# Work Order ID 51642

Item ID: D3492-043  
Revision ID: C  
Item Name: Plug Assembly

DRAWING NO. **D3492** REV. C  
SHEET 1 OF 2  
TITLE **PLUG** SCALE 2:1

DRAWING NO. D3492	TITLE PLUG	REV. C	DART AEROSPACE LTD ENGINEERING ORDER		D.E.O. NO. D3492-C-1	SHEET NO. SHEET 1 OF 1	SCALE NTS
DRAWN AJS	CHECKED	MFG. APPR.	APPROVED		DE APPR.		
DATE 08.11.05	DATE 08.11.05	DATE 08.11.05	DATE 08/11/05		DATE 08/11/05

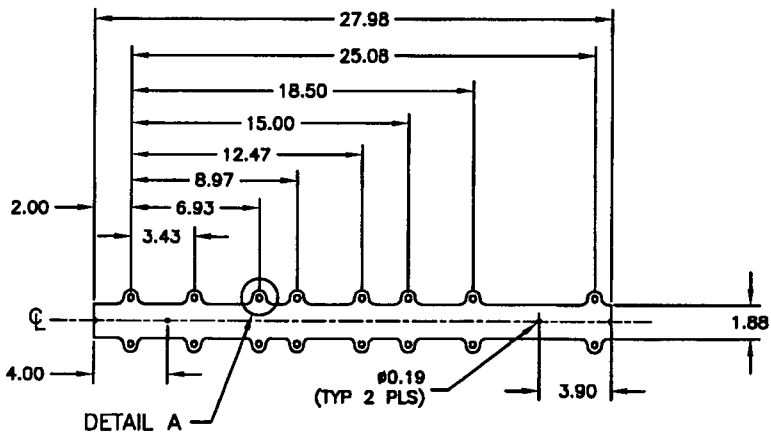
SHEET 2 MODIFY -13 PLUG AS SHOWN:

WAS:

P/N	A	B	C	MATERIAL SPEC
D3492-13	0.750	0.520	0.045	M6061T6R0.750

IS:

P/N	A	B	C	MATERIAL SPEC
D3492-13	0.750	0.510	0.045	M6061T6R0.750
